CITY OF SACRAMENTO
1231 I Street, Sacramento, CA 95814

Permit No: 9908371
Insp Area: 1

Nature of Work: T/O & REROOF TILE 50 SQS

Subject: Structural Investigation Report of the Roof for the Residence located at 159 Breckenwood Drive, Sacramento, CA 95864.

ROOF PLAN - CHINN

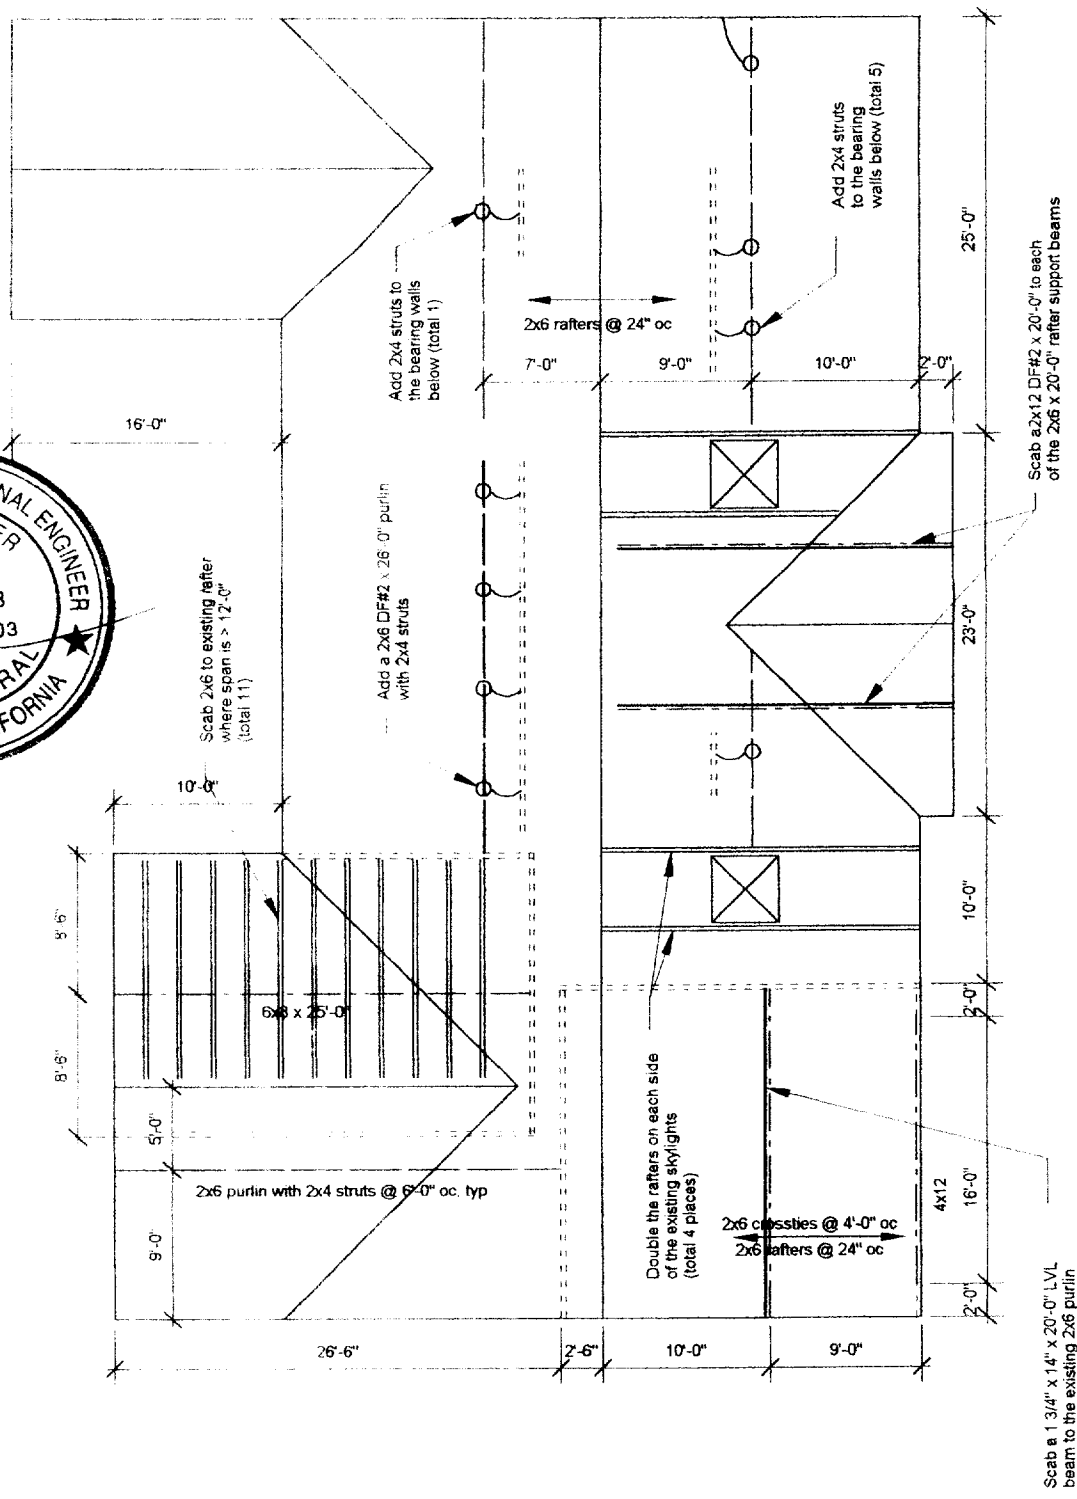
The living and garage areas lack sufficient structural capacity for the applied live and dead loads.

1. Add a 2x6 DF#2 x 26'-0" long purlin with 2x4 struts to the bearing walls below. See detail 1.
2. Provide additional 2x4 struts from the existing purlins to the bearing walls below. The maximum spacing between the new and existing struts shall not exceed 6'-0" on center and the minimum slope of the struts shall not be less than 45 degrees from the horizontal. See detail 1.
3. Scab a 2x12 DF#2 x 20'-0" beam to the existing 2x6 x 20'-0" rafter support beams and nail together with 16d's @ 12" oc. See detail 1.
4. Scab a 2x6 rafter to the existing 2x6 rafters with 16d's @ 12" on center where the span is greater than 12'-0". See detail 1.
5. Double the 2x6 rafters on each side of the existing skylights. Nail the rafters together with 16d's @ 12" oc. See detail 1.

1. Scab a 1 3/4" x 14" microlam beam to the existing 2x6 purlin and nail together with 16d's @ 12" oc. See detail 1.
